## ECE1200 Silicon Errata and Data Sheet Clarification

## Device Errata Issues

### 1. Module: Pin Glitch on Power-On

**FIGURE 1: RECOMMENDED ISOLATION USING BUFFERS**

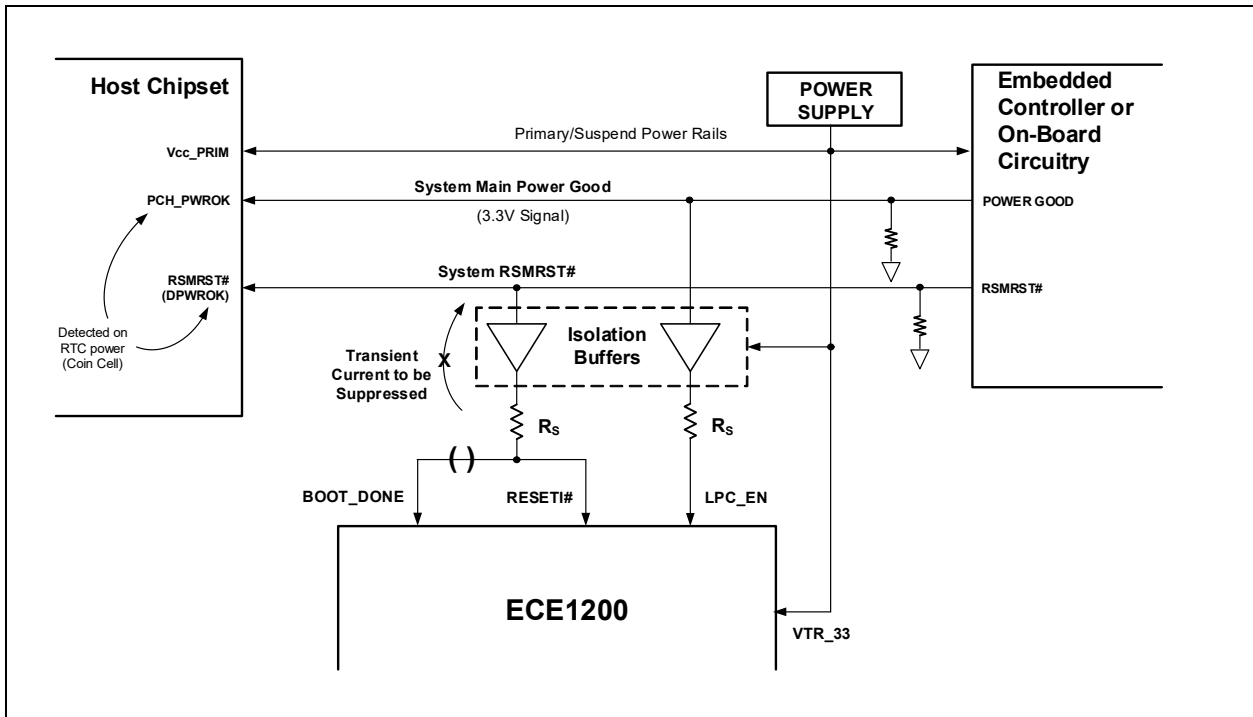
The Host Chipset may require that its RSMRST#, DPWROK and PCH\_PWROK input signals must be held securely low and never “glitch” high while their respective power wells are not yet fully powered. This is required even when the whole system is completely unpowered except for the Coin Cell “RTC” power well. This requirement is made to ensure that certain RTC-Well preserved resources like the CMOS RAM settings are not switched away from the Coin Cell prematurely. These signals typically come from an Embedded Controller, SIO or board-level circuitry in the system, and these sources are designed to obey the anti-glitch requirement.

However, the signal pin structures (even of input pins) on the ECE1200 can in fact appear to drive high as outputs, as a transient condition while the VTR\_33 power rail is rising. For this reason, it is not guaranteed that these levels will not propagate as invalid levels to the Host’s glitch-sensitive pins if the connection is made directly. Chapter 1 of the ECE1200 Data Sheet contains figures that illustrate functional connections, but they do not include the isolation circuitry that is necessary to avoid this potential glitch propagation.

It is recommended that any ECE1200 input pins that are driven from System RSMRST#, DPWROK or PCH\_PWROK are isolated from them so that they cannot drive current back into the system. The pins at issue are RESETI# and sometimes BOOT\_DONE, when connected to Host RSMRST# and/or DPWROK, and LPC\_EN when connected to Host PCH\_PWROK.

[Figure 1](#) below shows a recommended method of isolation, using unidirectional buffers. A small series resistor  $R_S$  is shown, to ensure transient current is well below the buffer device’s  $I_{OL}$  during power-up, for reliability purposes only.

(Note: The connection to drive BOOT\_DONE in parallel with RESETI# is not mandatory. BOOT\_DONE can be connected to just a pull-up resistor to VTR\_33 instead, as a constantly-high strap, and will operate correctly.)
